**UNITED STATES DEPARTMENT OF COMMERCE****United States Patent and Trademark Office**Address: COMMISSIONER OF PATENTS AND TRADEMARKS
Washington, D.C. 20231*sk*

Office Action Summary

This is the first office action for application number 09/610,510, Apparatus For Stiffening A Hanger Rod, filed on July 6, 2000.

3,318,561

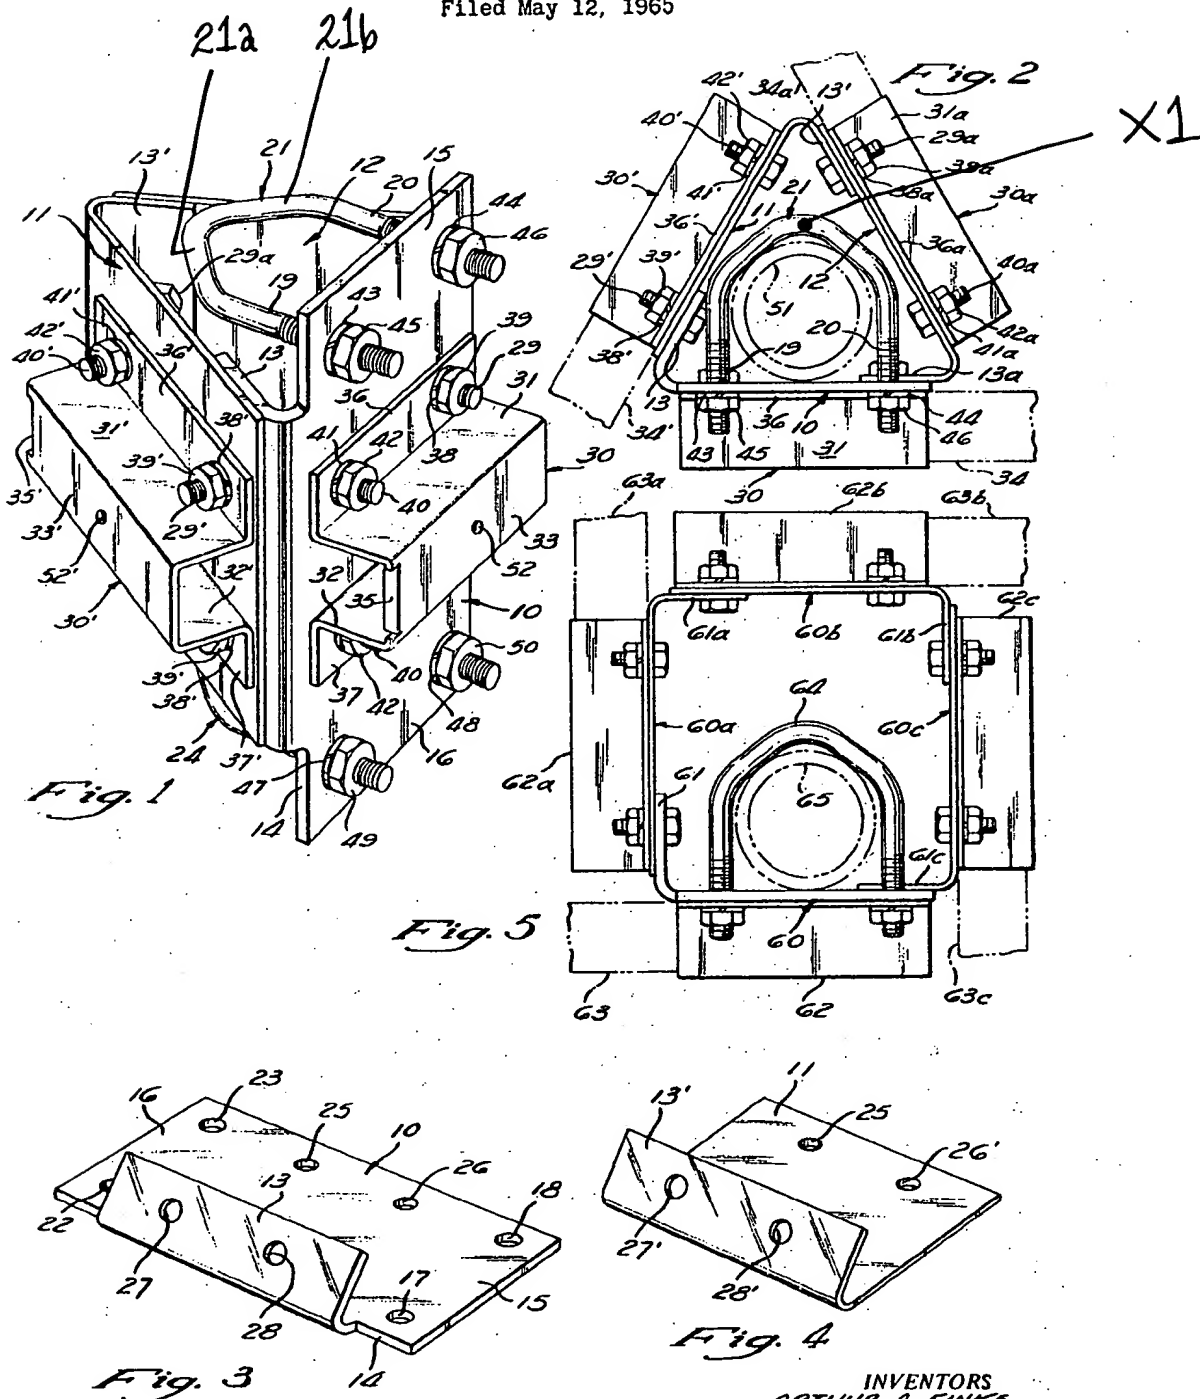
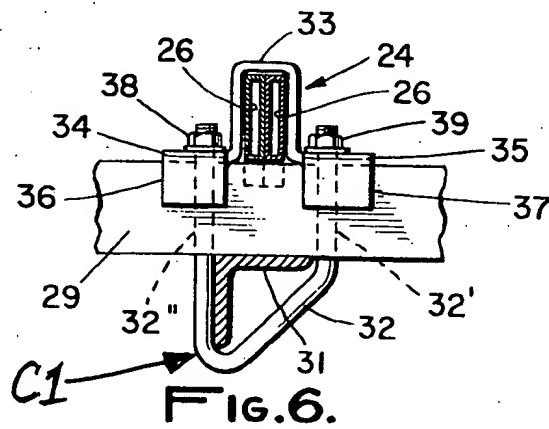
Claims 1-2, 4, 7 and 9 are rejected under 35 U.S.C. 102(b) as being anticipated by U.S. Patent 3,318,561 to Finke et al. Finke et al. discloses a stiffener apparatus (note attached marked-up copy of Figs. 1-2) including a clamp 21, a plate 10, nuts 46 and an elongated stiffener member 51. Finke et al. discloses that the clamp has two straight, double-ended, spaced, parallel first clamp segment 19 and second clamp segment 20, and a third clamp segment 21a,21b integral with and extending between an end of the first clamp segment and an end of the second clamp segment. In addition, Finke et al. discloses that the plate 10 (note Fig. 3) defines spaced openings 17,18 where the ends of the first and second clamp segments which are remote from the third clamp segment project through the openings (note Figs. 1-2).

Finke et al. also discloses that nuts threadedly engage with the ends of the first and second clamp segments which project through the openings (note Figs. 1-2). Furthermore, Finke et al. discloses that the elongated stiffener member is disposed between the plate and the third clamp segment (note Fig. 2) wherein at least a portion 21a,21b of the third clamp segment is straight and non-orthogonally disposed relative to

the first and second clamp segments and cooperable with the elongated stiffener member to continuously exert lateral forces.

Finke et al. also discloses that the third clamp segment includes an interconnected first straight portion 21a and second straight portion 21b extending at obtuse angles with respect to the first and second clamp portions (note Fig. 2). Additionally, Finke et al. discloses that the first and second portions connect at a location X1 substantially midway between the first and second clamp segments. Finally, Finke et al. discloses that the stiffener member has a circular-shaped outer peripheral bearing surface (note Fig. 2).
